ADDENDUM NO. 1

WASHINGTON STATE PARKS AND RECREATION COMMISSION KOPACHUCK STATE PARK DAY USE DEVELOPMENT SW-C1811

DATE: April 16, 2024

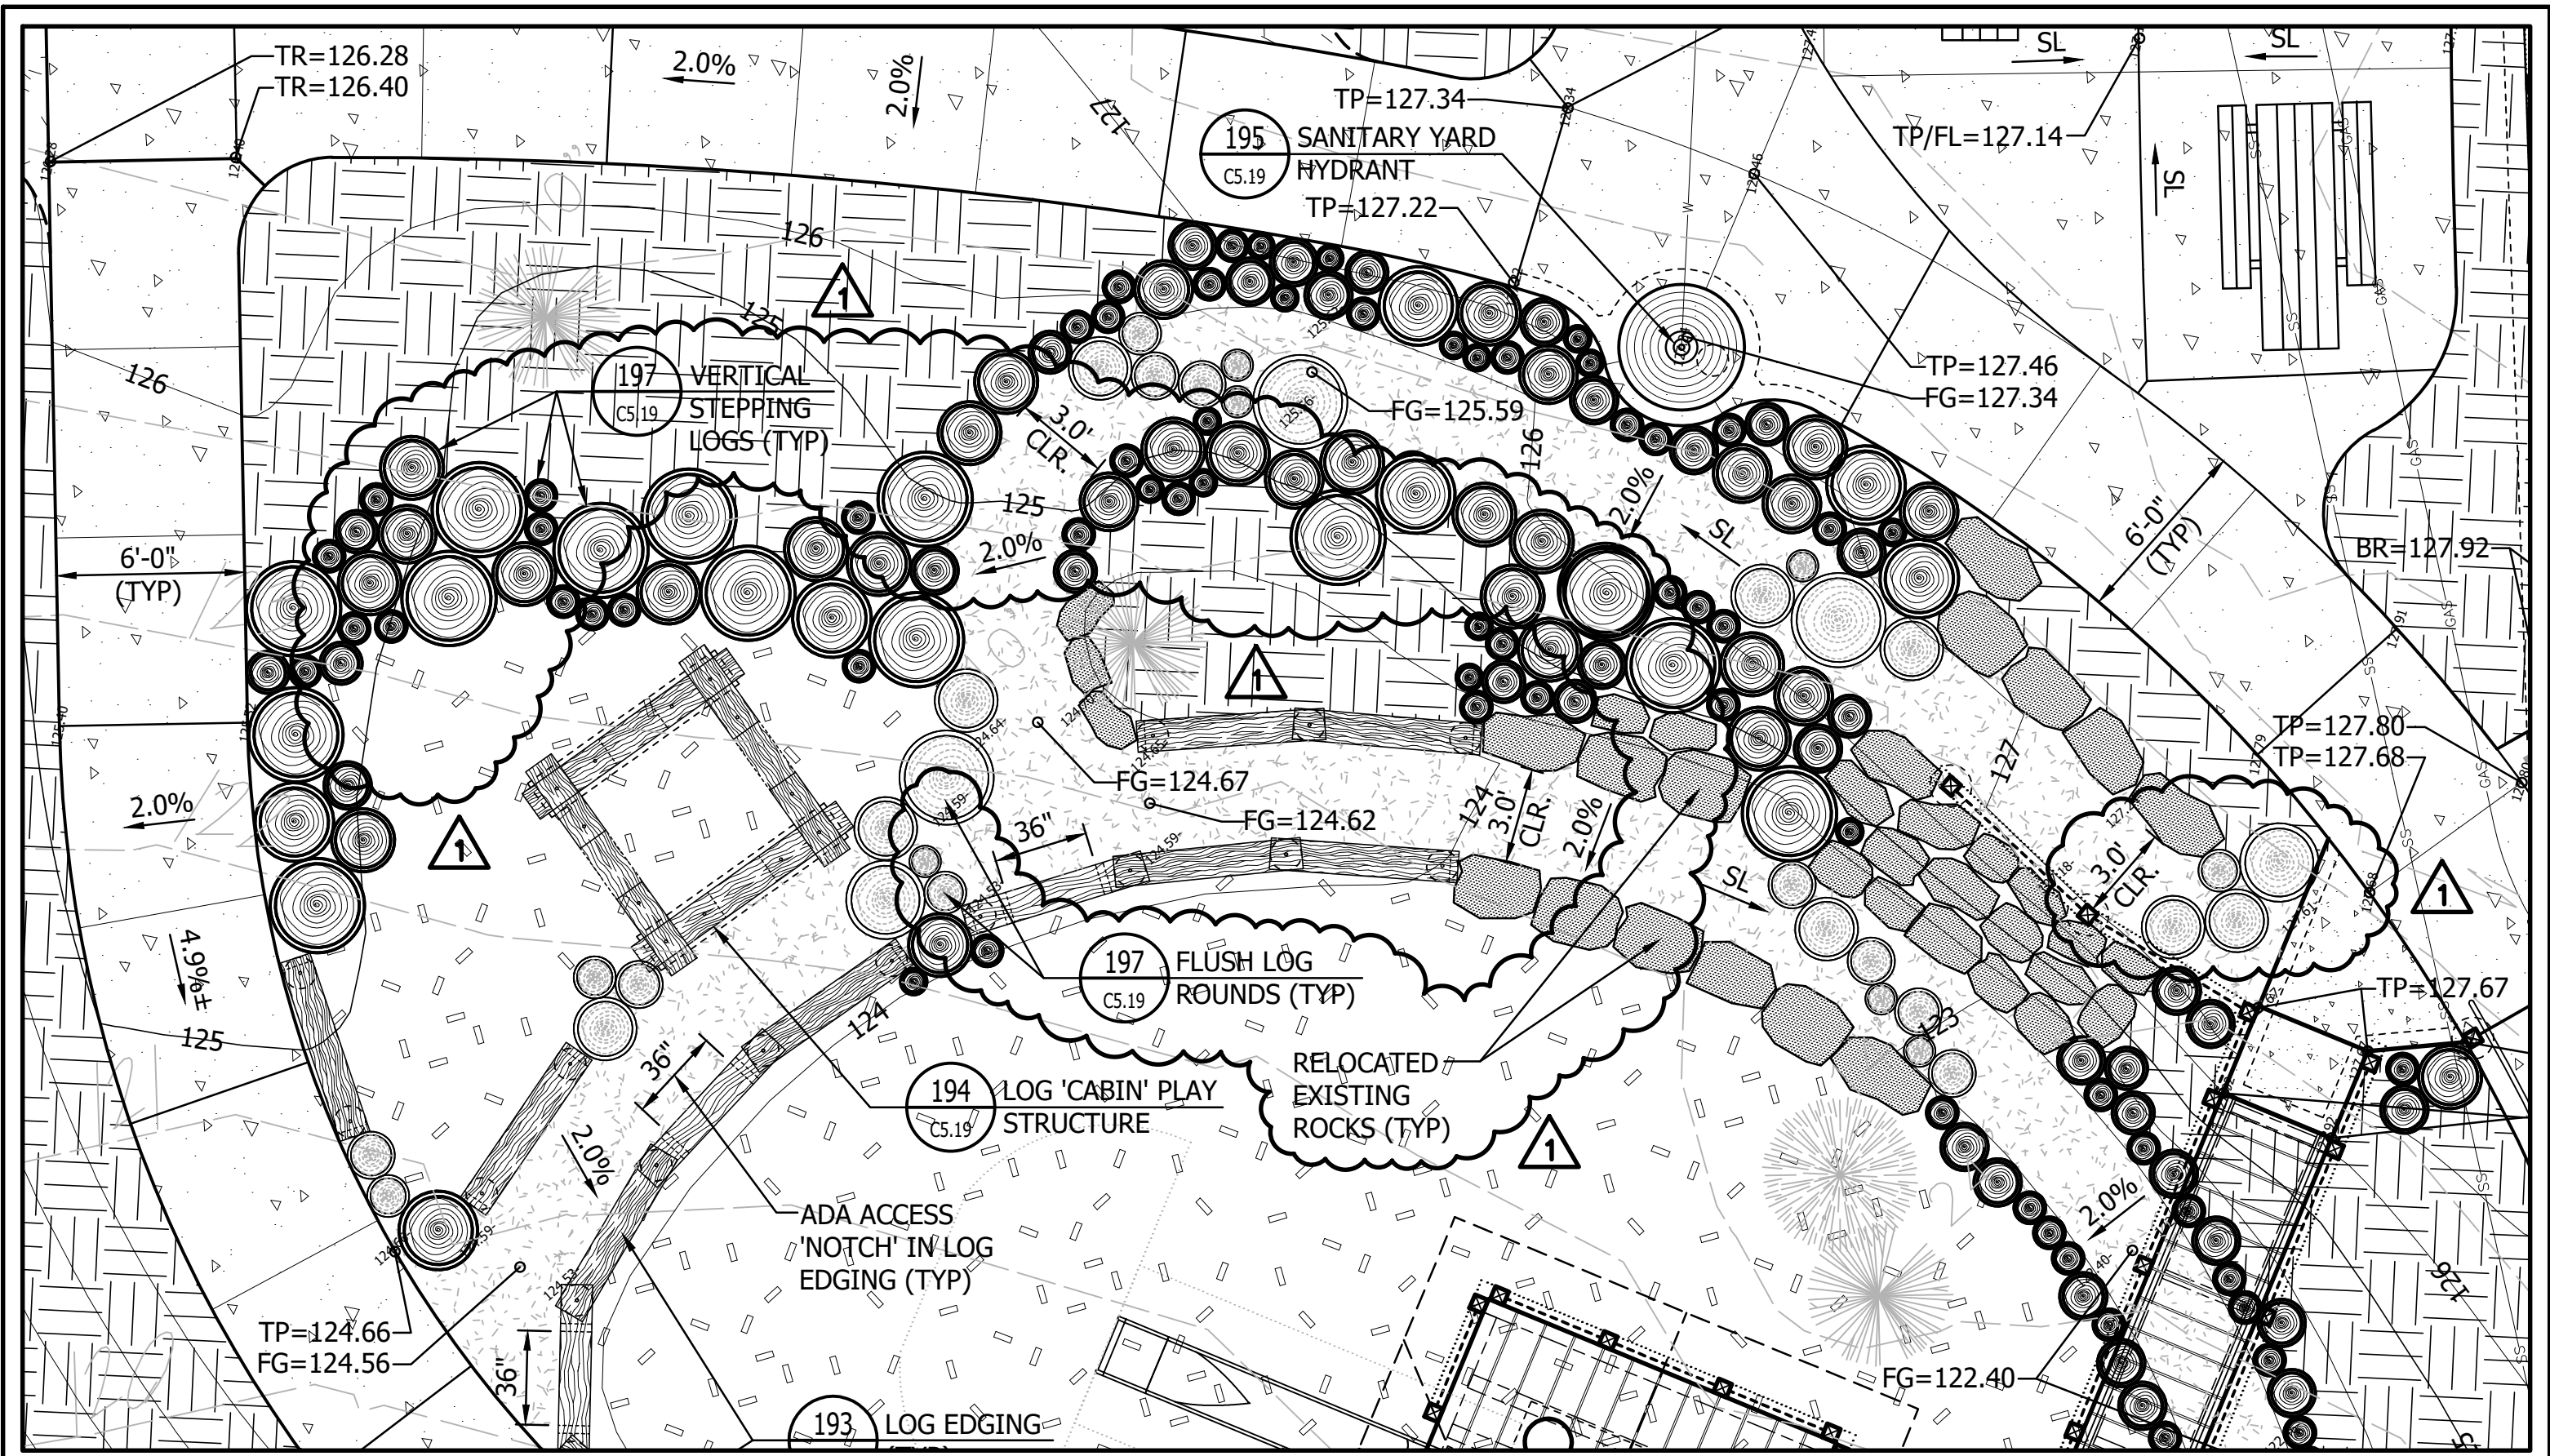
Sheet C5.16: **Revise:** Callouts and notes on Detail 160 as shown clouded on Addendum Sketch ADD-1.01 attached.

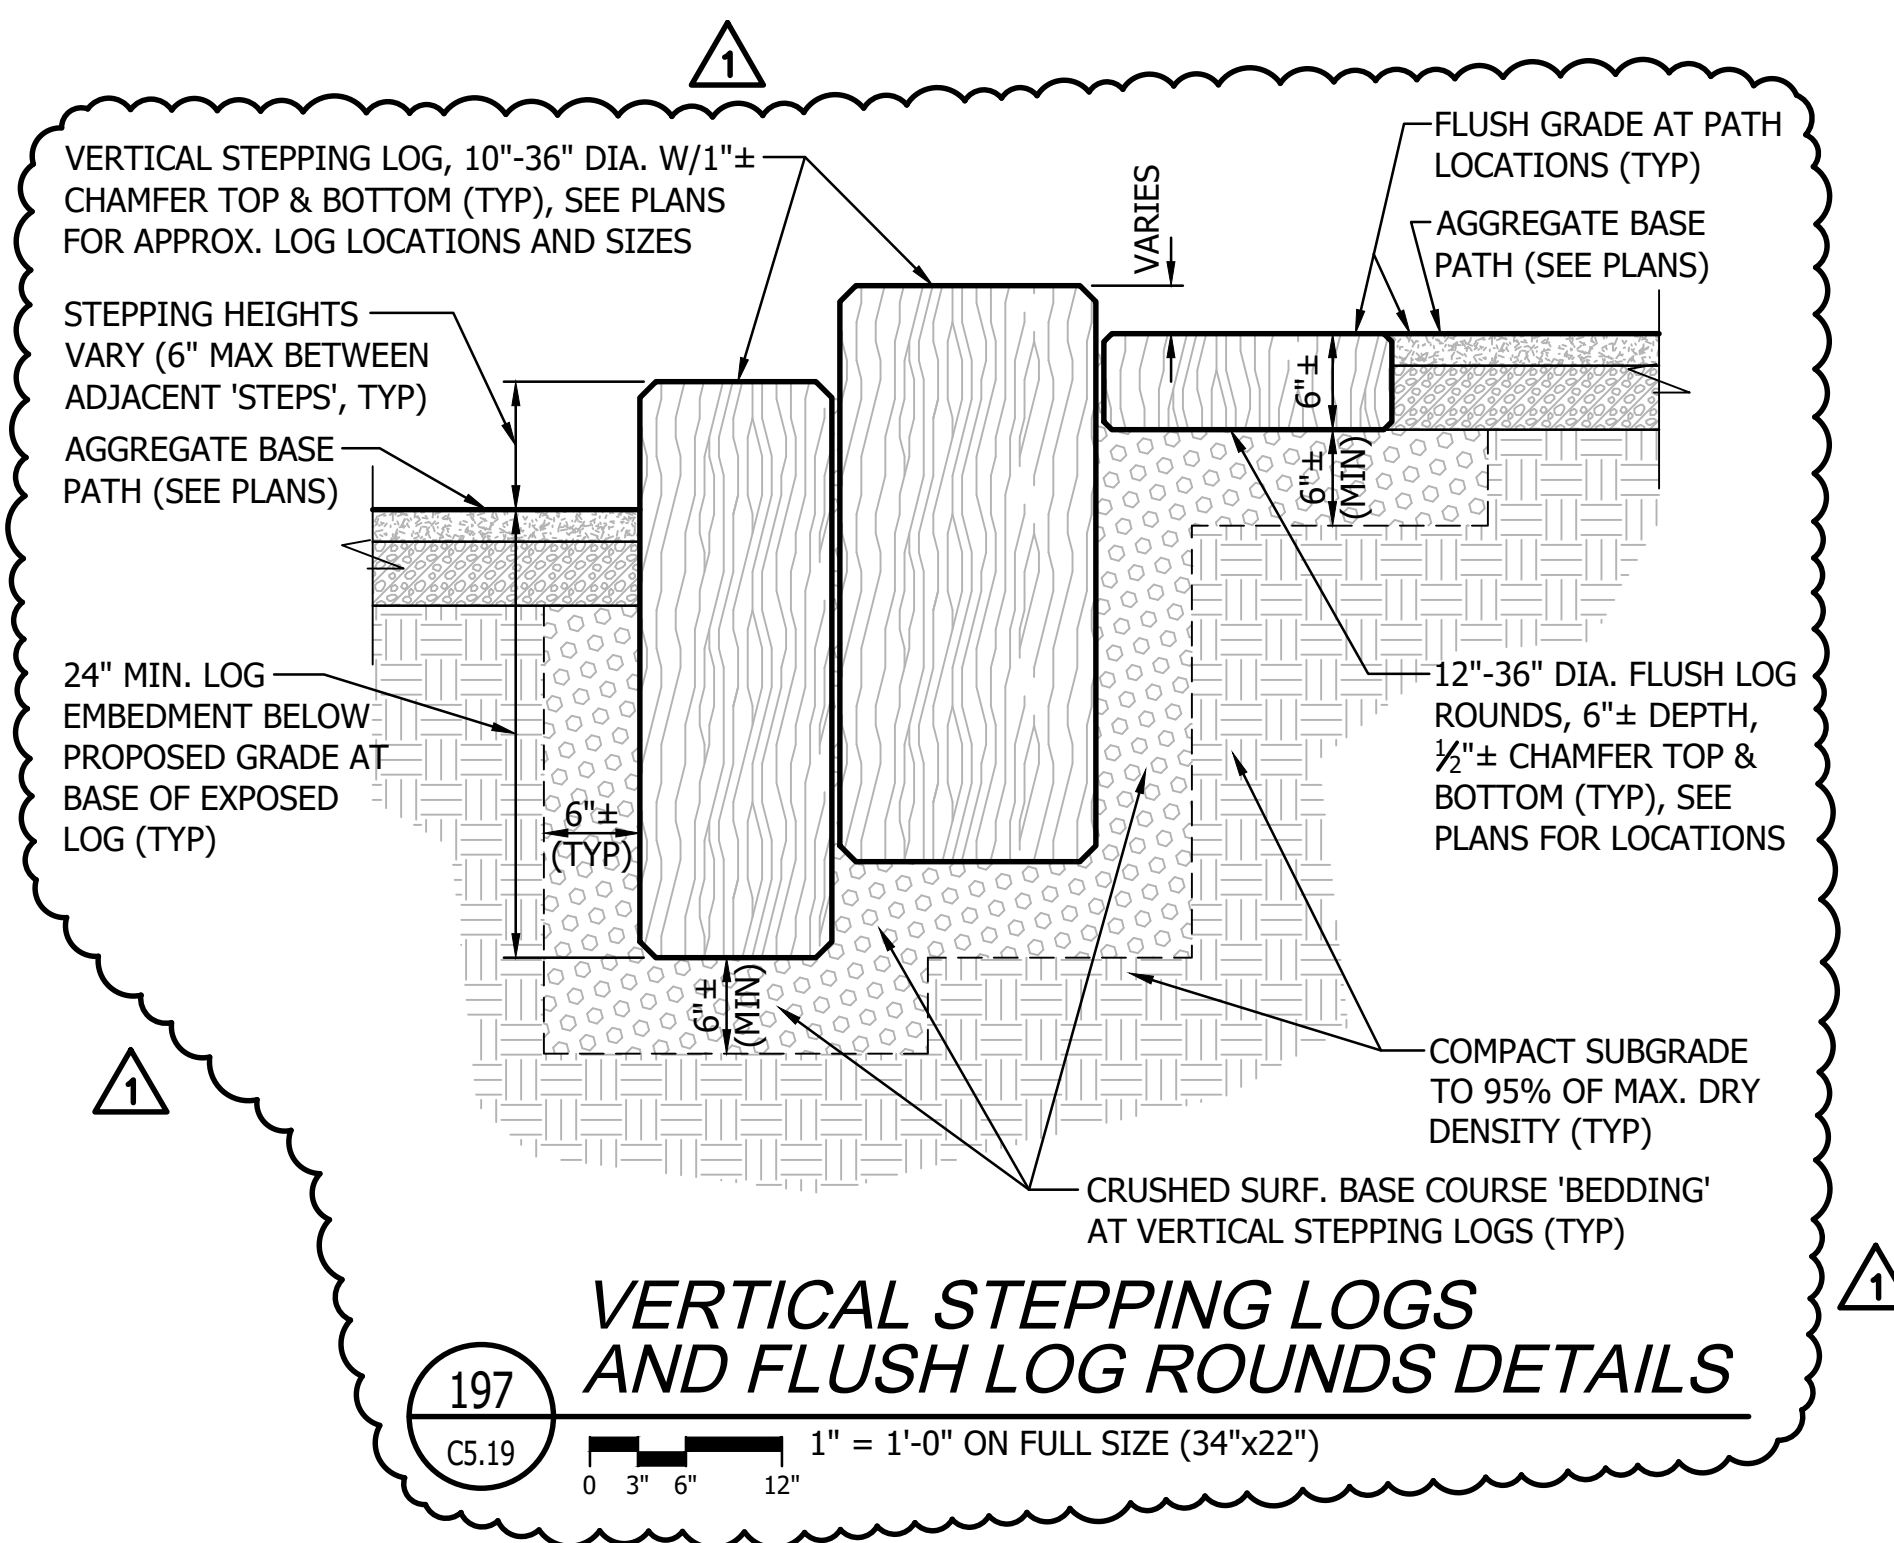
Sheet C5.19: **ADD:** NEW detail 197 – Vertical Stepping Logs and Flush Log Rounds as shown clouded on Addendum Sketch ADD-1.02 attached.

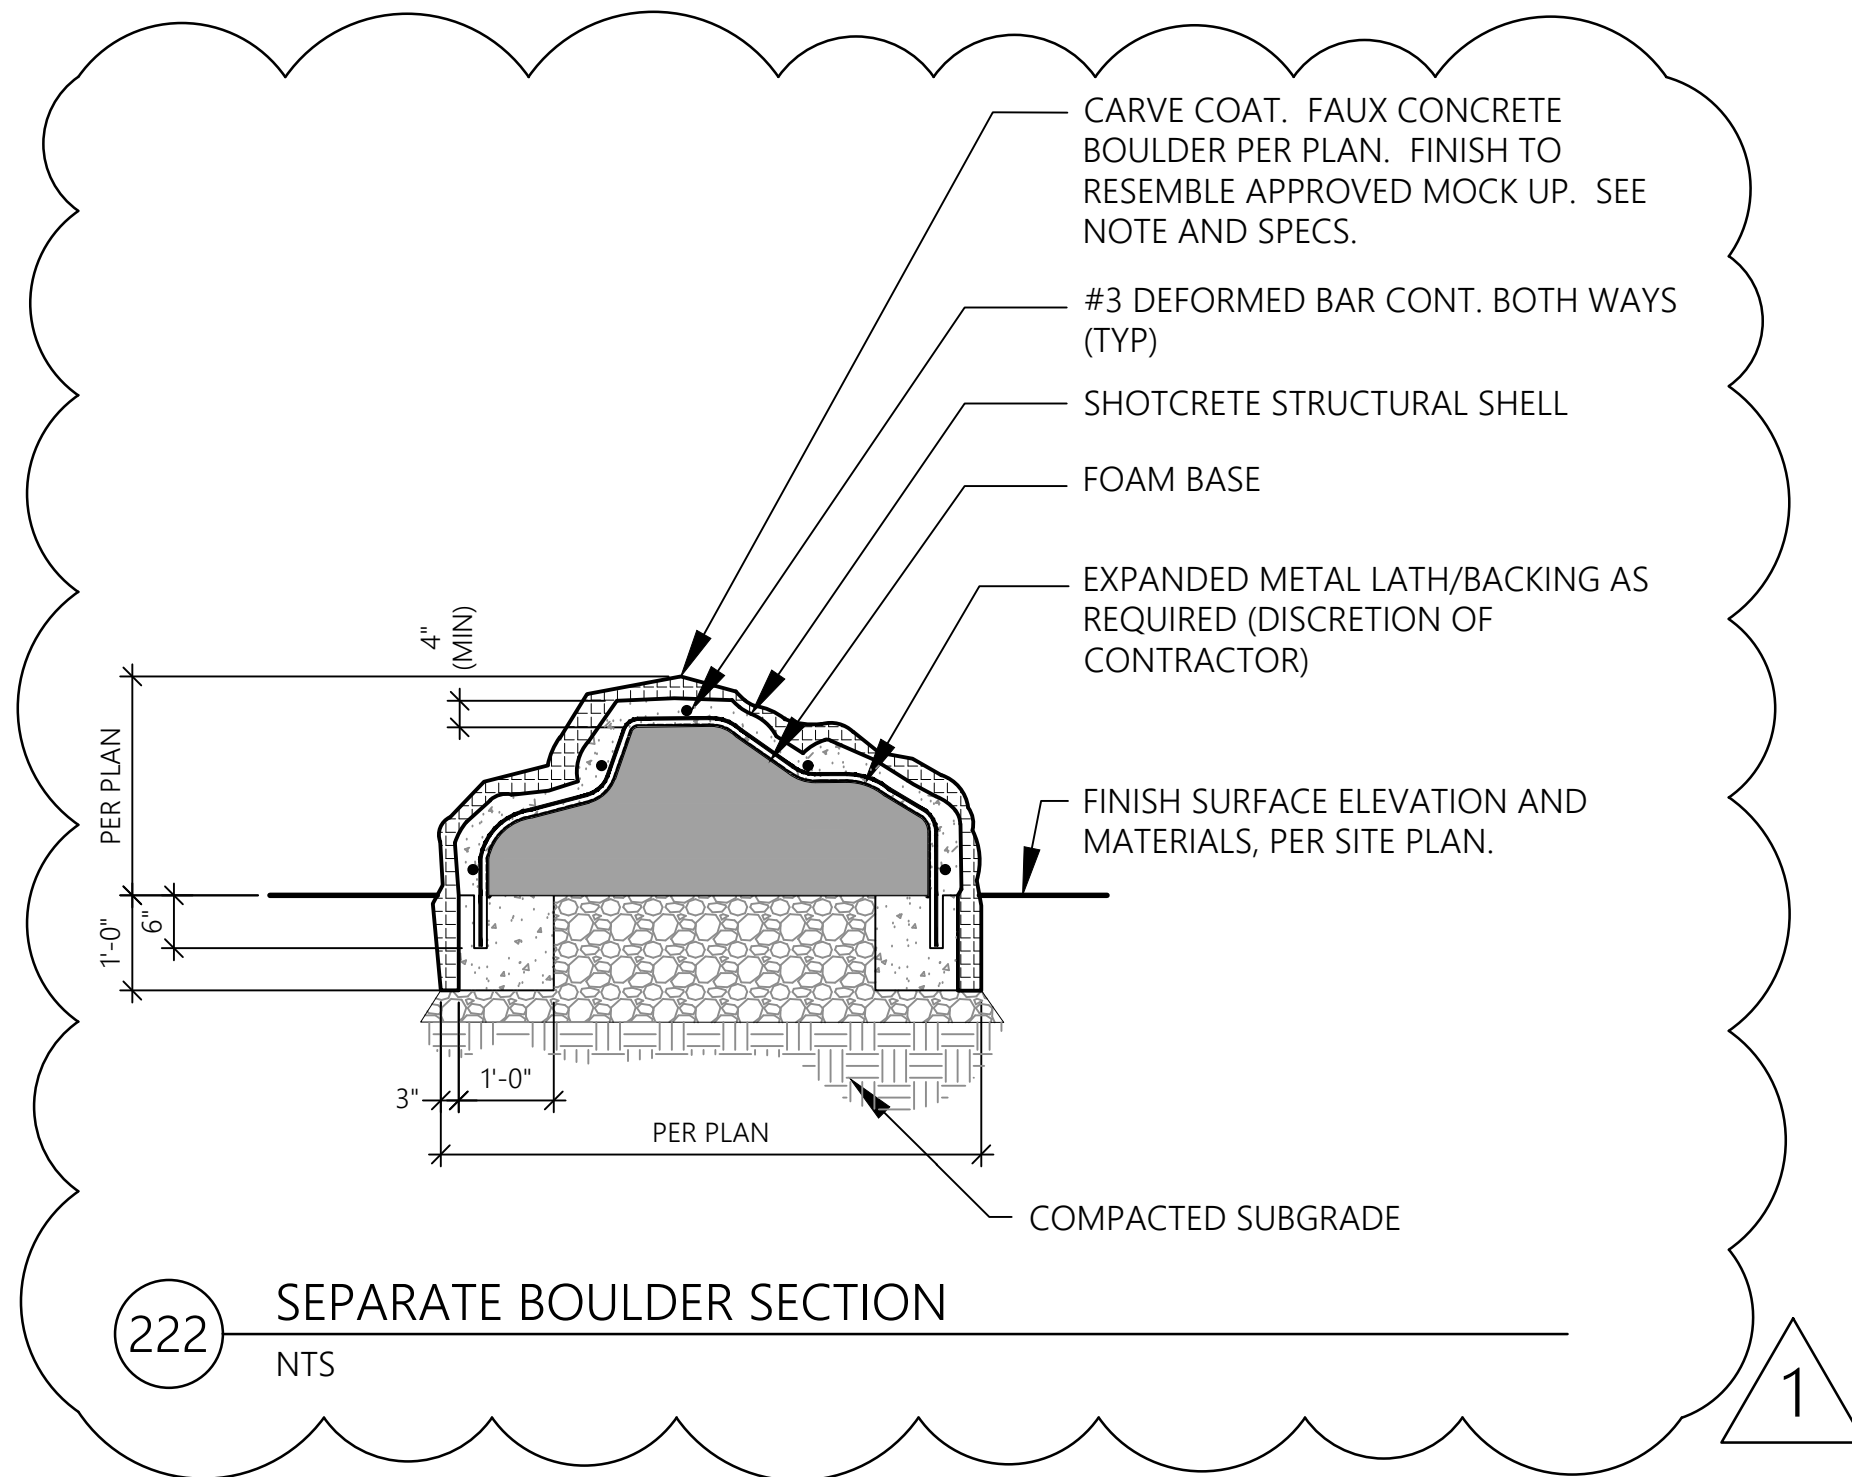
Sheet C5.22: **Revise:** Detail 222 – Separate Boulder Section as shown clouded on Addendum Sketch ADD-1.03 attached.
